Access Compliance Report

Public Rights-of-Way

(Curb Ramps)

Intersection ID: 48559	Main Street: RIDGEFOREST_DR	Cross Street: ARDREY_WOODS_DR	Location:	E
ADA ID: 96CD73CB84B1	Ramp Type: Perp	Initial Pass/Fail: Fail	Overall Compliance: No	Severity Score: 12.5
Codes/Mitigation Info/Possible Solution		Field Measurements/Component Compliance

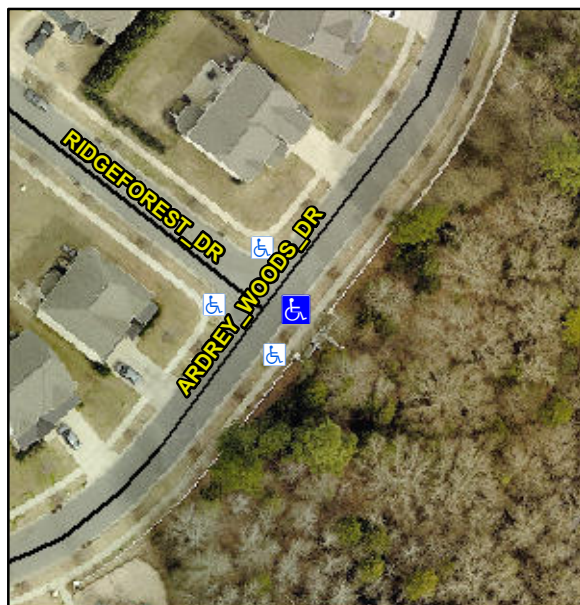
Not Found, R304.2.2

Compliance	Description	Data	Compliance	Description	Data
N/A	Ramp Length (in)	71.0	No	Ramp Slope (%)	8.8
Yes	Ramp Width (in)	59.0	Yes	Ramp XSlope (%)	1.0
N/A	Flare Type LT	N/A	N/A	Flare Type RT	N/A
N/A	Flare Slope LT (%)	N/A	N/A	Flare Slope RT (%)	N/A
N/A	Flare Traversable LT?	N/A	N/A	Flare Traversable RT?	N/A
N/A	Landing Length (in)	N/A	N/A	DWS Provided?	N/A
N/A	Landing Width (in)	N/A	N/A	DWS Contrast?	N/A
N/A	Landing Slope (%)	N/A	N/A	DWS Length (in)	N/A
N/A	Landing X Slope (%)	N/A	N/A	DWS Full Width?	N/A
N/A	Landing Curb? (Y/N)	N/A	N/A	DWS Offset (in)	N/A
N/A	Shared Landing?	N/A			
N/A	Gutter Ponding?	N/A	N/A	Gutter Slope (%)	N/A
N/A	Gutter Lip Ht (in)	N/A	N/A	Gutter X Slope (%)	N/A
N/A	Painted X Walk1?	No	N/A	Painted X Walk2?	N/A
	X Walk 1 Direction	To NW		X Walk 2 Direction	N/A
N/A	X Walk 1 Width (in)	N/A	N/A	X Walk 2 Width (in)	N/A
	X Walk 1 Slope (%)	3.6		X Walk 2 Slope (%)	N/A
	X Walk 1 X Slope (%)	0.7		X Walk 2 X Slope (%)	N/A

Remove & Replace Entire Ramp.
